City of NAPOLEON, OHIO

Re: Snyder-Wesche Funeral Home
Proposed Parking Improvements

Please note the following comments pertaining to the layout of the proposed parking lot just north of the Snyder-Wesche Funeral Home.

Re: Snyder-Wesche Funeral Home
Parking Lot Improvements

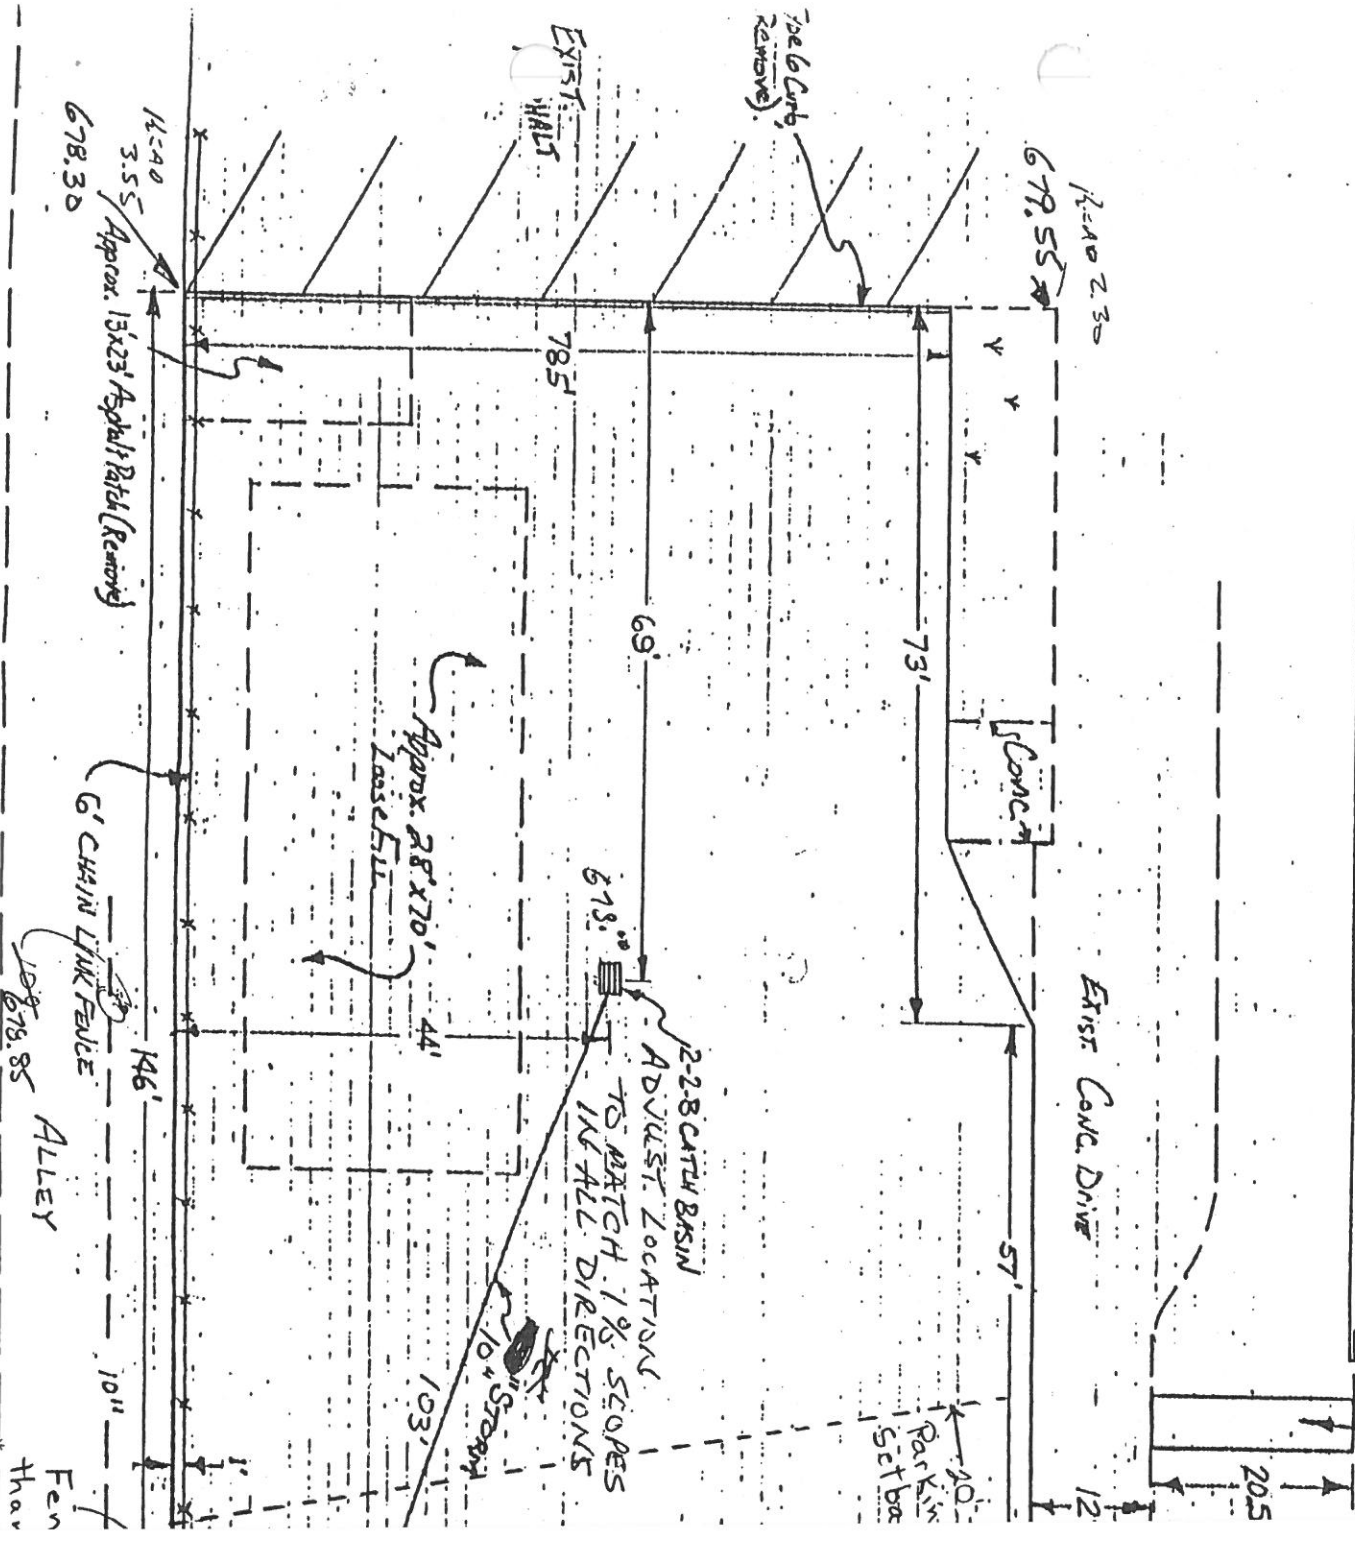
- 1.) Property lines must be shown on the sight plan.
- 2.) The City of Napoleon Zoning Code requires a twenty (20) foot setback from the right-of-way on Scott Street for parking.

- 3.) Copies of Subsection 151.66 and 151.67 are enclosed to show the required dimensions and location for parking spaces.
- 4.) The proposed chain link fence along the north property line may not extend into the right-of-way, nor can it be higher than three (3) feet within fifteen (15) feet of the right-of-way of Scott Street.

- 5.) Due to the fact that the proposed storm sewer extension along Scott Street and the existing storm outlet were sized assuming 40% impervious conditions and the fact that the proposed improvements will result in approximately 90% impervious conditions, we will require that the proposed storm outlet be a 10" @ 0.30%. The originally proposed 12" @ 1.00% would allow the runoff to reach the storm sewer too rapidly.

- 6.) The proposed storm outlet may be connected to the existing combined sewer on the east side of Scott Street provided the invert of the storm outlet, within four (4) feet of the combined sewer, is high enough to allow for the outlet to be extended across Scott Street to the proposed storm sewer extension.
- 7.) A permit will have to issued by the Engineering Department prior to the start of work.

PARKING SETBACK

2-2-8 CATCH BASIN
ADJUST LOCATION TO MATCH 1% SLOPES IN ALL DIRECTIONS

10" STORM
